**Re: State of Tennessee Position in the Formal Dispute Initiated by the U.S. Environmental Protection Agency on August 24, 2018, on the *Focused Feasibility Study for Water Management for the Disposal of CERCLA Waste on the Oak Ridge Reservation, Oak Ridge, Tennessee (DOE/OR/01-2664&D2)***

**RE: Focused Feasibility Study [FFS] for Water Management for the Disposal of CERCLA Waste on the Oak Ridge Reservation, Oak Ridge, Tennessee (DOE/OR/01-2664&D2)**

**Explanation of Significant Differences for the Record of Decision for the Disposal of Oak Ridge Reservation Comprehensive Environmental Response, Compensation, and Liability Act of 1980 Waste, Oak Ridge, Tennessee (DOE/OR/01-2322&D1)**

Figure 4.14. Mean concentrations of mercury in rockbass from BCK 3.3, redbreast sunfish from BCK 9.9, and rockbass from the Hinds Creek reference site (HCK 20.6) 1990 – 2014.

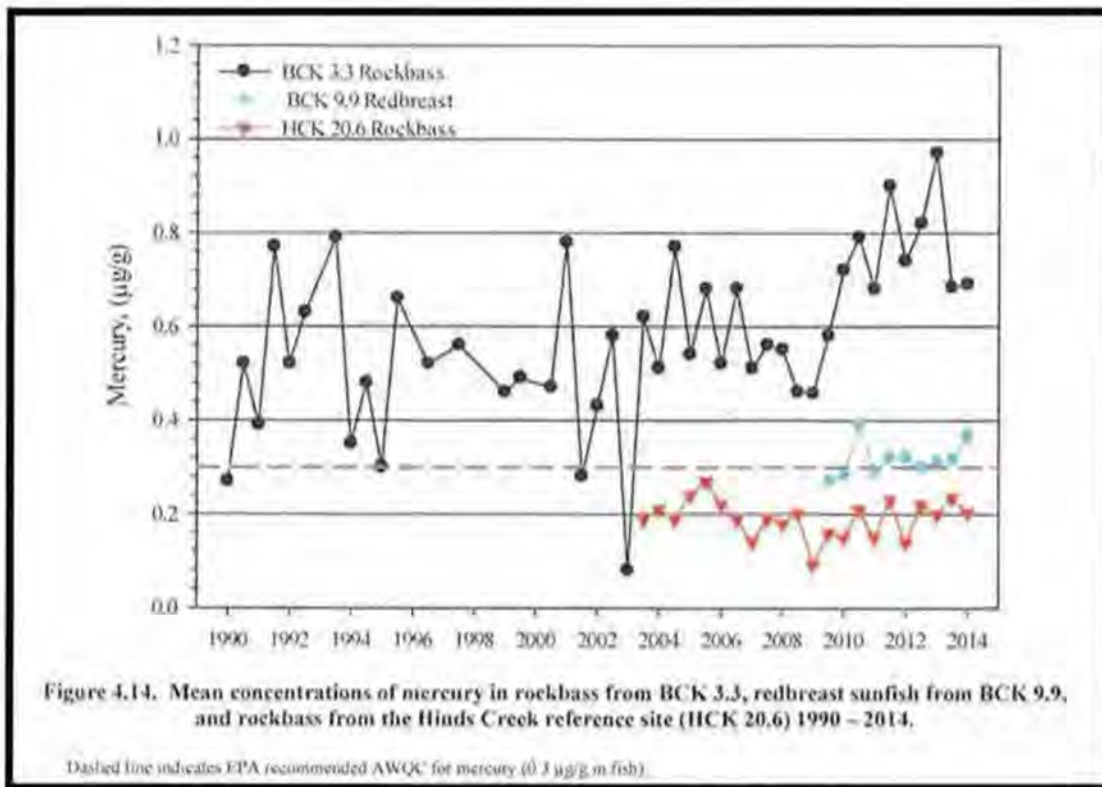
Bear Creek and downstream surface water are classified for recreation (e.g. fishing and fish consumption) and other uses and impaired water quality in Bear Creek is not a new issue. Bear Creek continues to be included on TDEC's Division of Water Resources 2017 proposed final year 2016 303(d) list due to mercury and other pollutants. Figure 4.14 of the 2015 Oak Ridge Department of Energy Remediation Effectiveness Report, shown below, graphically represents mercury concentrations in fish (Rockbass at BCK 3.3 and Redbreast at BCK 9.9) downstream of EMWMF in Bear Creek over time. HCK 20.6 is a background reach used for comparing mercury concentrations in Rockbass.

This graph indicates something changed after 2009 causing an increase in concentrations of mercury in downstream Rockbass. The data show that four of eleven samples (36%) collected since 2009 are greater than or equal to the highest levels observed since 1990. This trend is disturbing in light of the fact that DOE proposes to construct another disposal facility in Bear Creek Valley that would potentially receive additional mercury bearing waste from demolition of facilities in the West End Mercury Area (WEMA) at Y-12.

TDEC will not be issuing specific comments on the subject ESD at this time because of the unresolved issues of the disputed FFS that will likely result in changes to the ESD. Given that mercury has been and may be continuing to be discharged above allowable limits and mercury accumulation in fish from Bear Creek shows an increasing trend as opposed to decreasing, it is TDEC's position that DOE develop the following:

- 1) A detailed schedule for resolution of issues associated with water management at the EMWMF and proposed EMDF; and
- 2) Discharge limits for chemical and radiological contaminants that are consistent with CERCLA, DOE Orders and ARARs; and
- 3) A plan to identify and correct discharges of mercury above allowable limits.
